GREENSBRIDGE LANE, HALEWOOD, LIVERPOOL

TRANSPORT STATEMENT ADDENDUM

Project No	Revisions / Status	Description	Issue	Checked	Approved	Date
359-22-4	First Draft		1	JP	MP	17/01/2025
359-22-4	Final		1	JP	MP	21/01/2025

Title
Visibility Splays

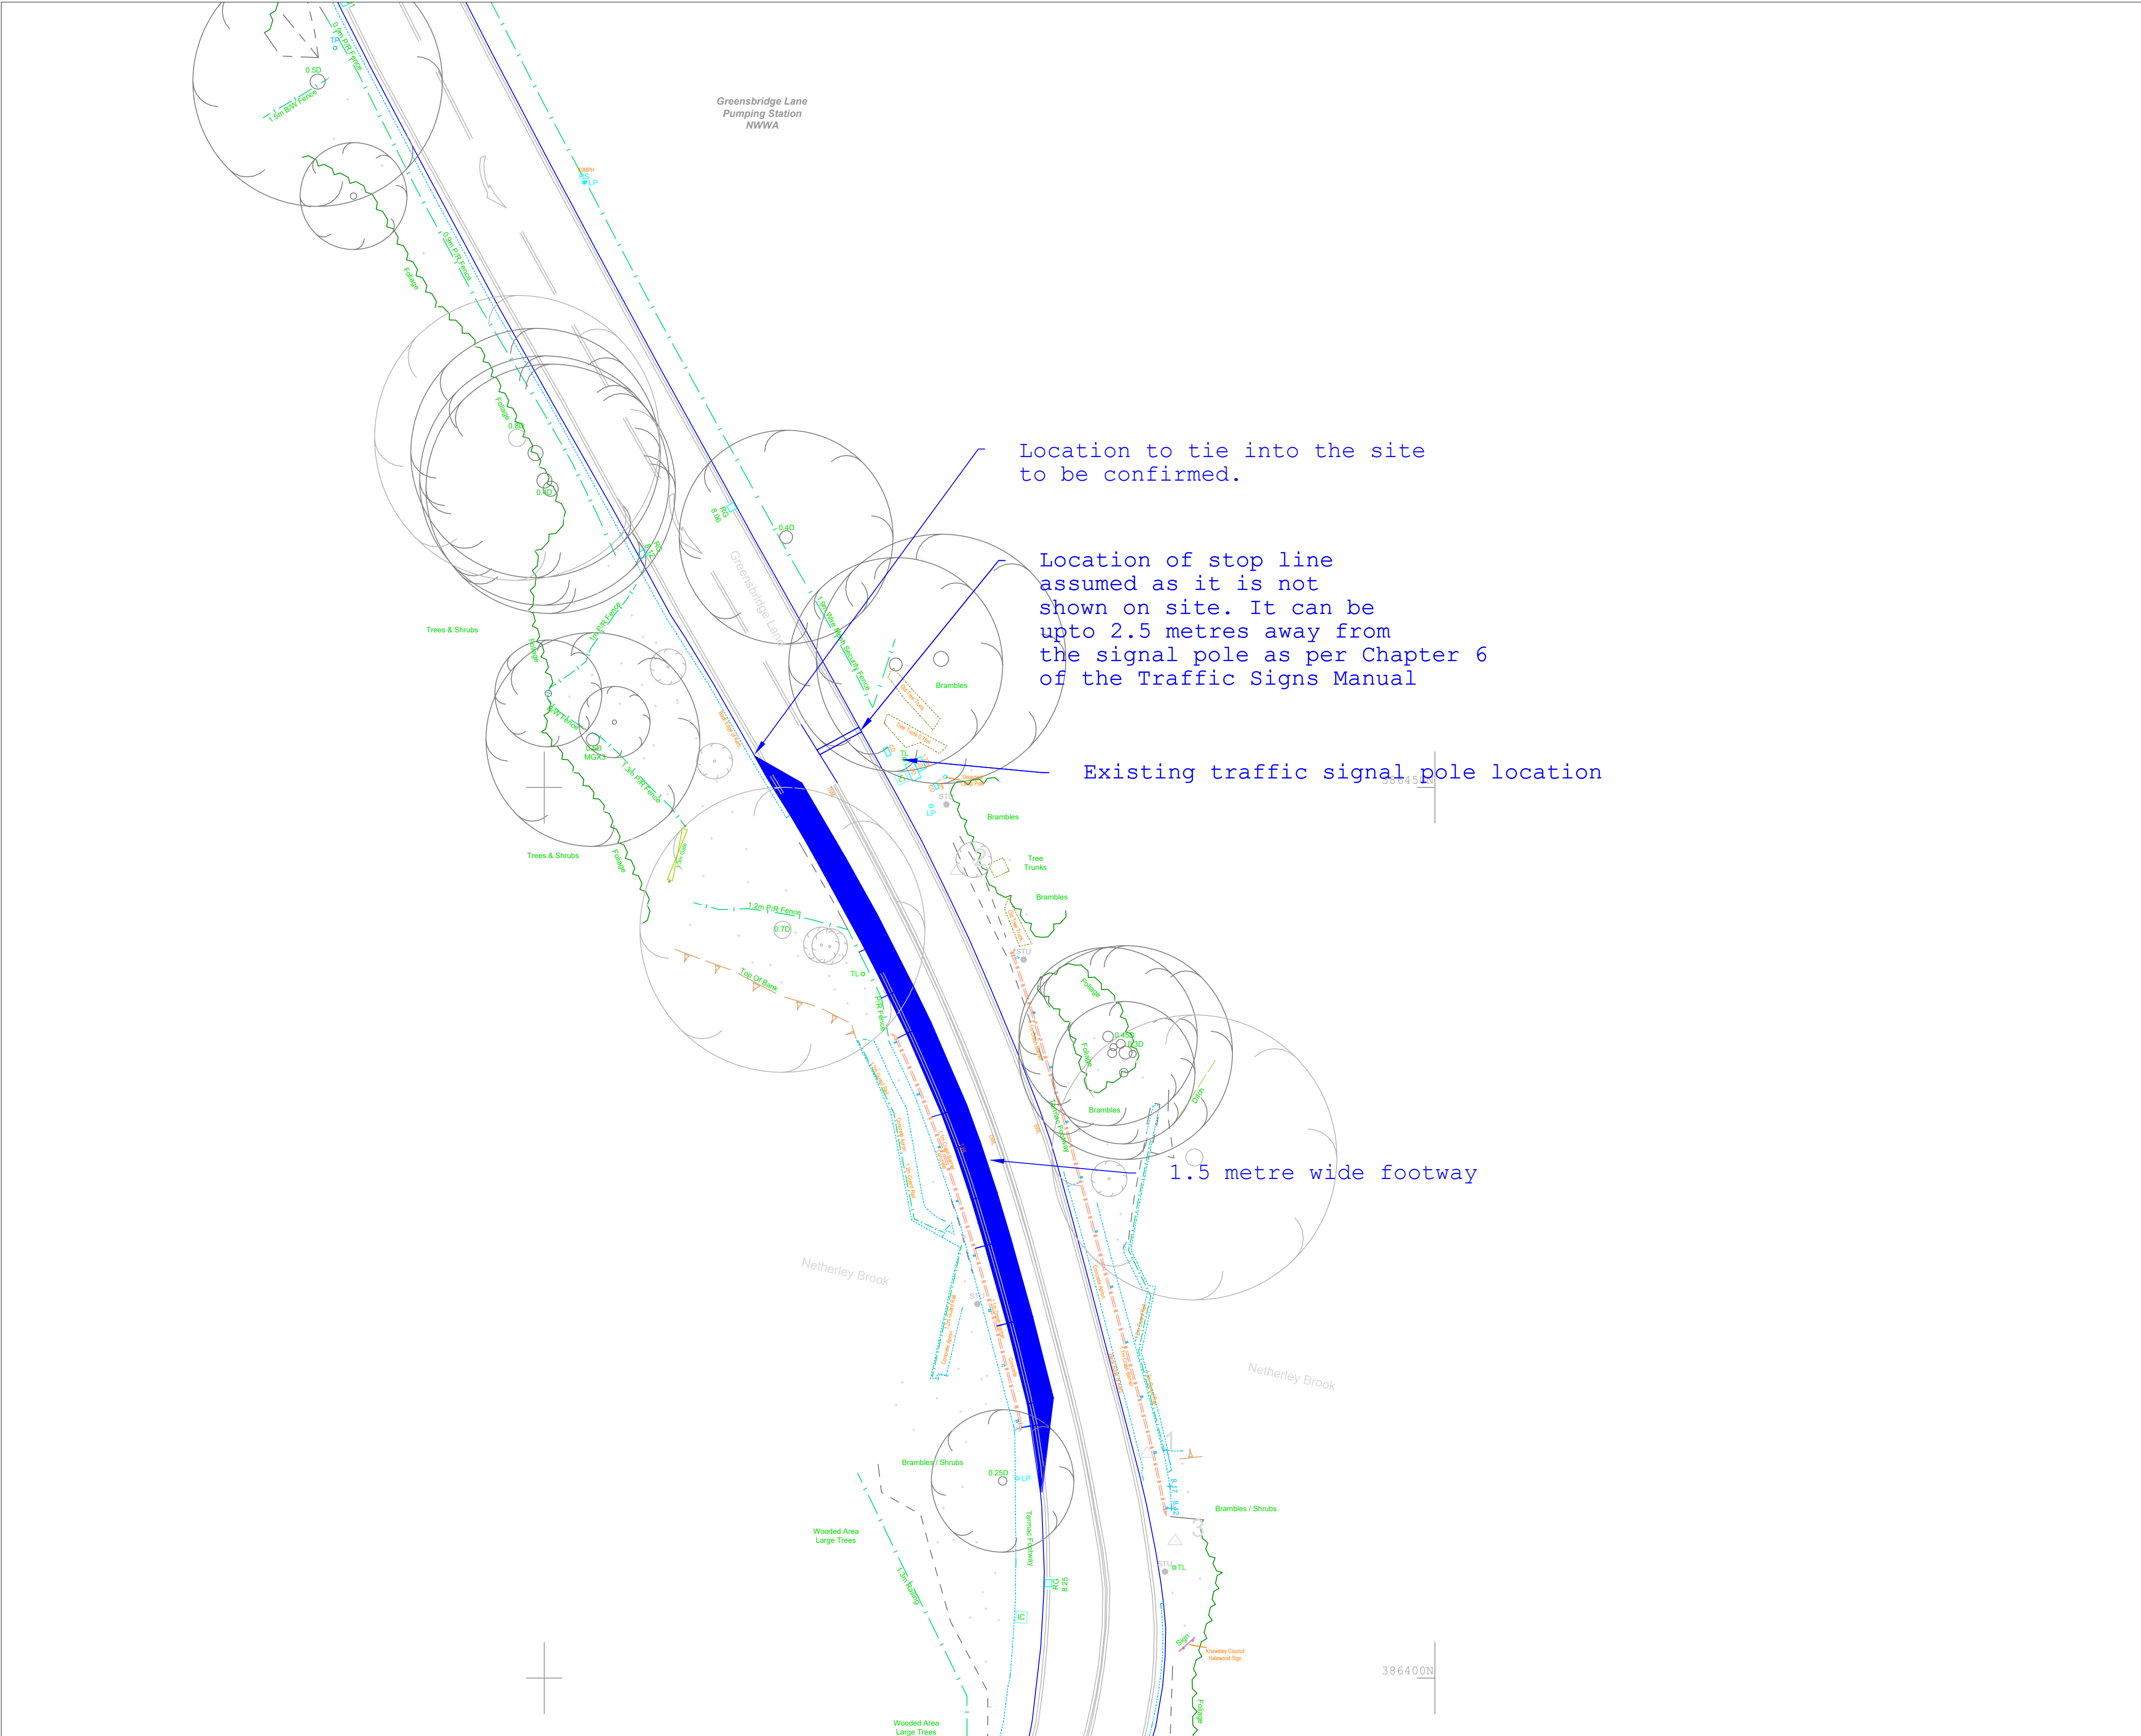
- 2.2 One of the highways matters that needed further work on was the visibility splay for the site access. Plotting of the tangent points as per Manual for Streets guidance was requested by the Highways Officer.
- 2.3 The tangent point for the visibility splays to the left and right have now been produced. The attached drawing shows the visibility splays with the tangent lines now included.
- 2.4 The visibility splay drawing has been updated and it is provided in **Appendix A**.

Revisions
A - revised site layout 2.5.2024
B - revised site layout 25.5.2024
C - revised to include additional check as per Highway Officer request 28.11.2024

Title
Footway Over Bridge 1.5m wide

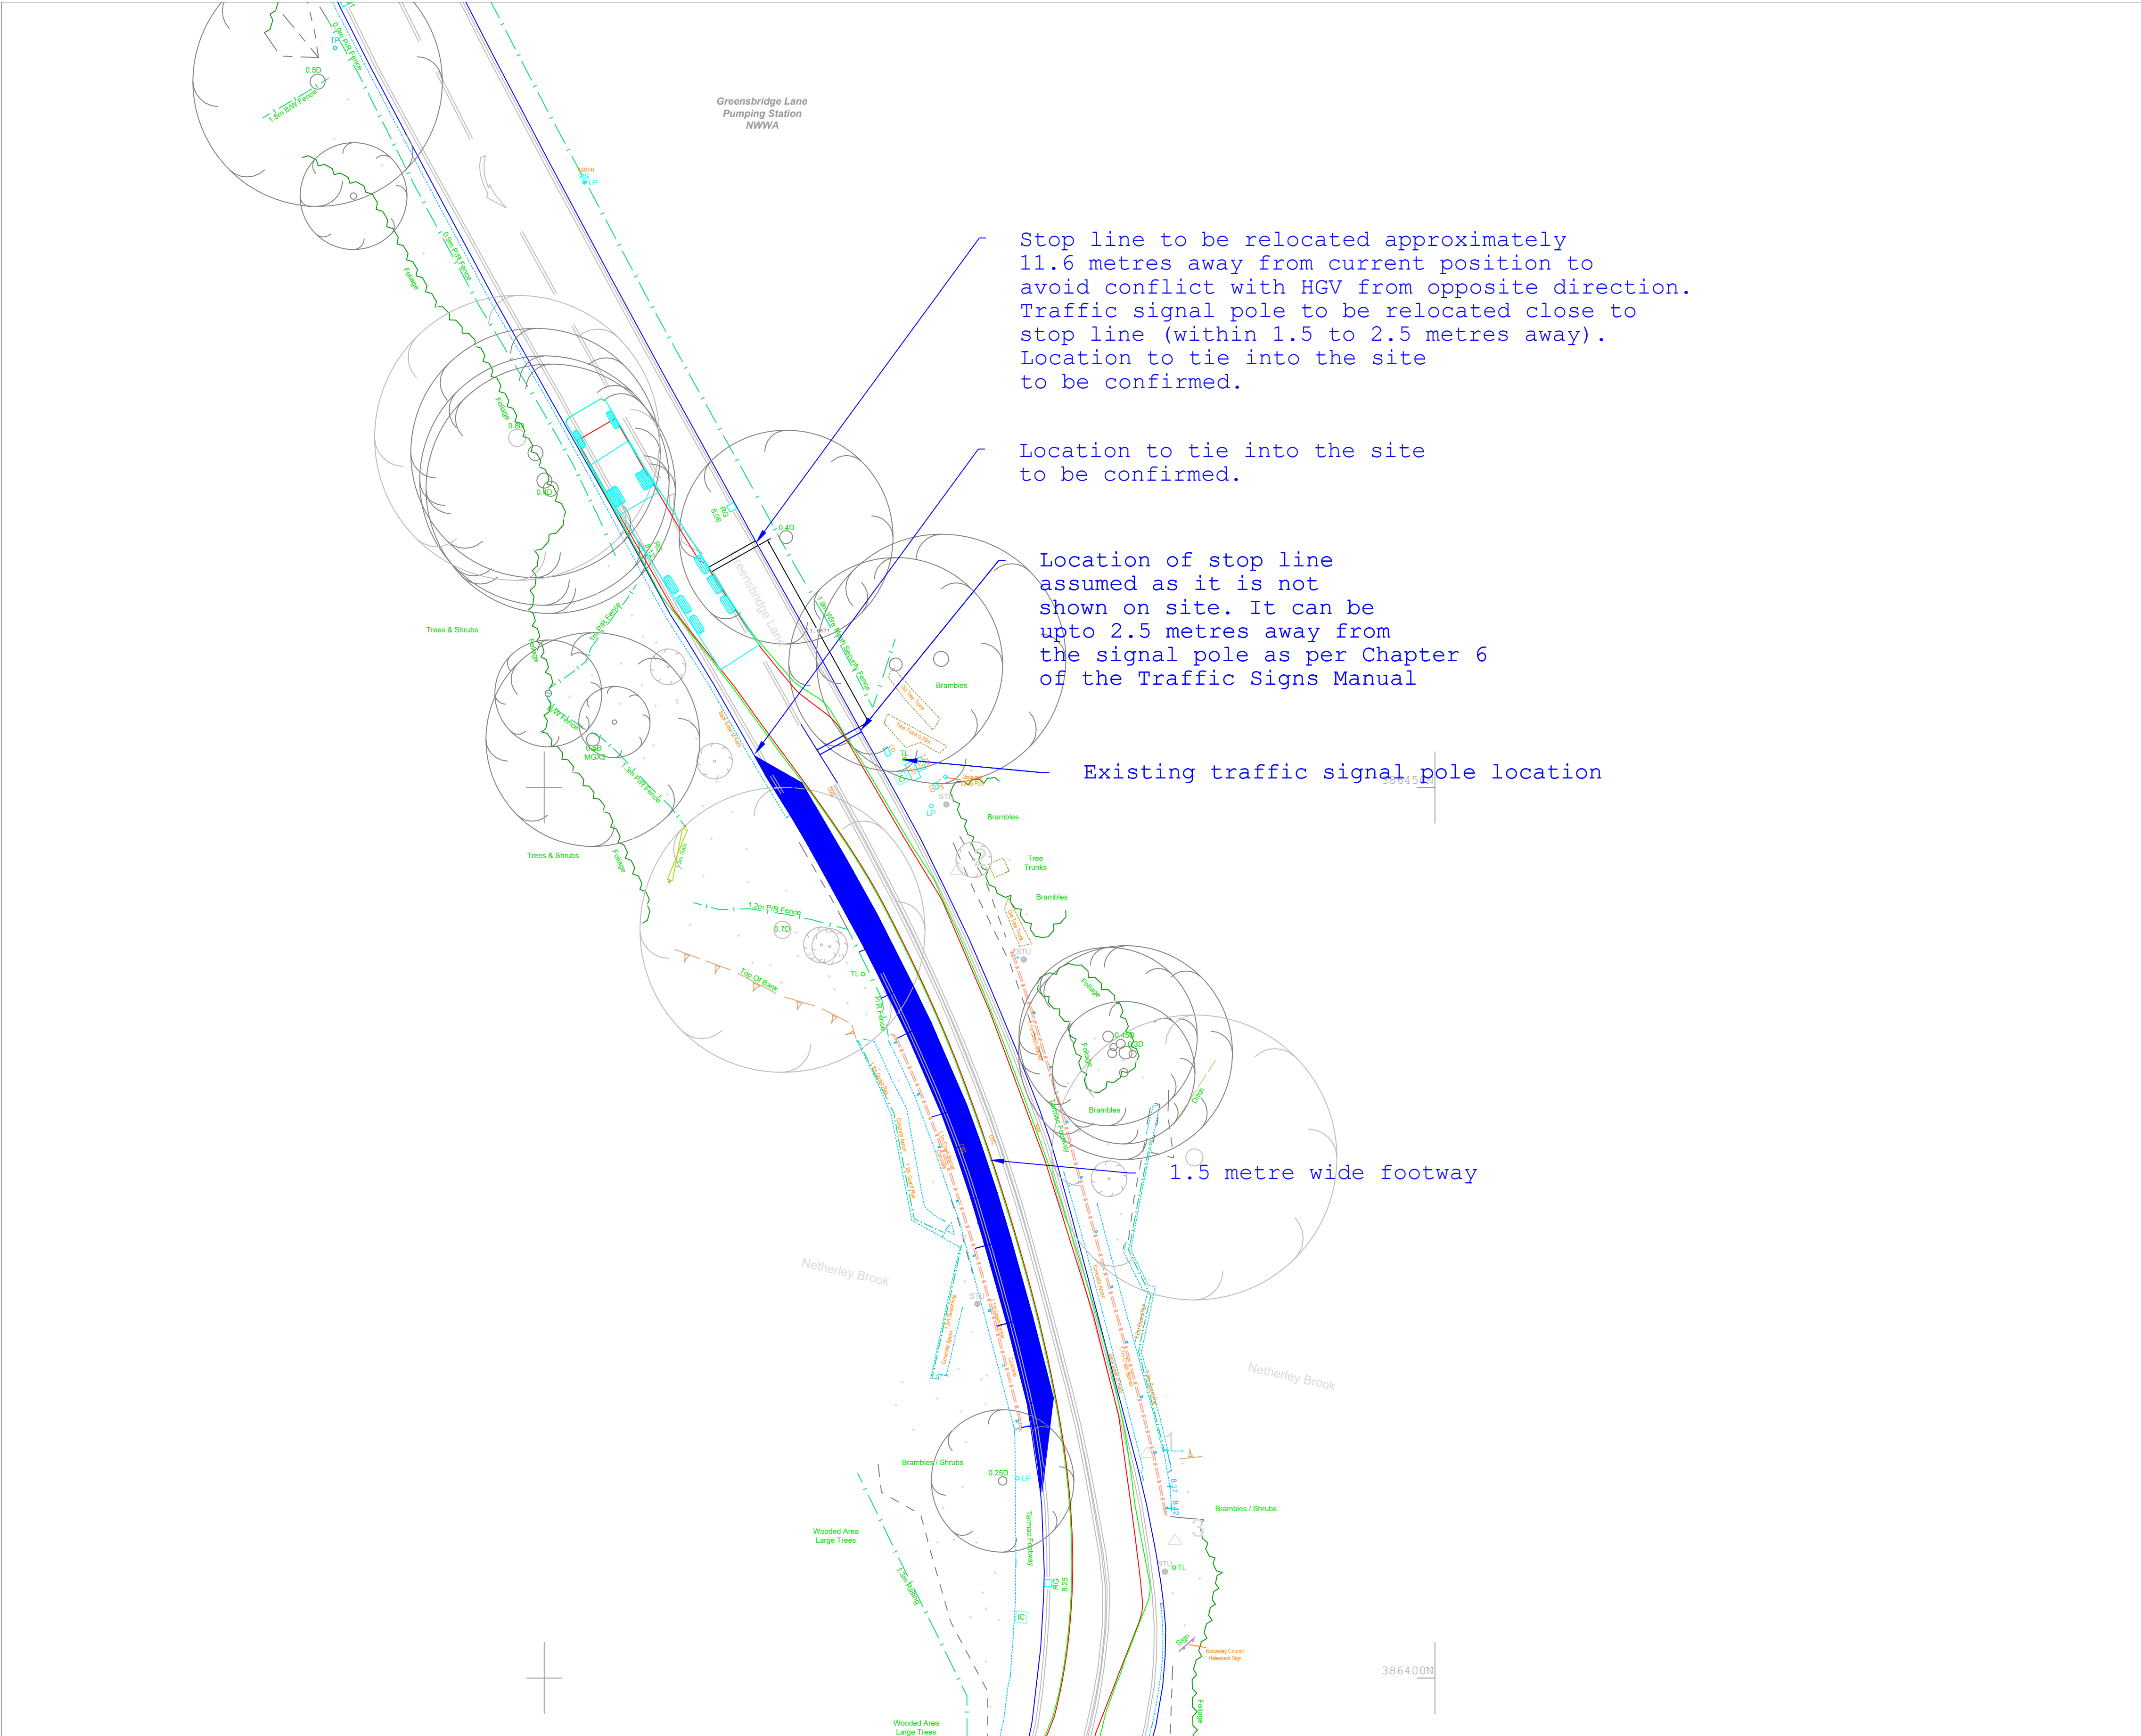
- 2.9 The other option developed consists of a 1.5 metre wide footway. An articulated vehicle can travel along the road and over the bridge without coming into conflict with the proposed kerb / proposed footway. However, the stop line would still need to be relocated approximately 11 metres to avoid conflict with opposing vehicles at the stop line.
- 2.10 Both of the options are now submitted to the Council to seek the views of the Highway Authority to see if either option would be supported.
- 2.11 Drawings showing both of the options and vehicle tracking are included. The 2.0m wide footway option has the vehicle tracking combined within the site arrangement.
- 2.12 The pedestrian improvement options are shown in **Appendix B**.

- Notes
1. Stop line is missing from site so assumed position using Chapter 6 of Traffic Signs Manual.
 2. 1.5m footway.
 3. Stop line will need to be relocated circa 11. metres from existing.
 4. Additional ducting, etc to be confirmed. Acceptability in terms of additional intergreen times in the signal phase will need to be checked.
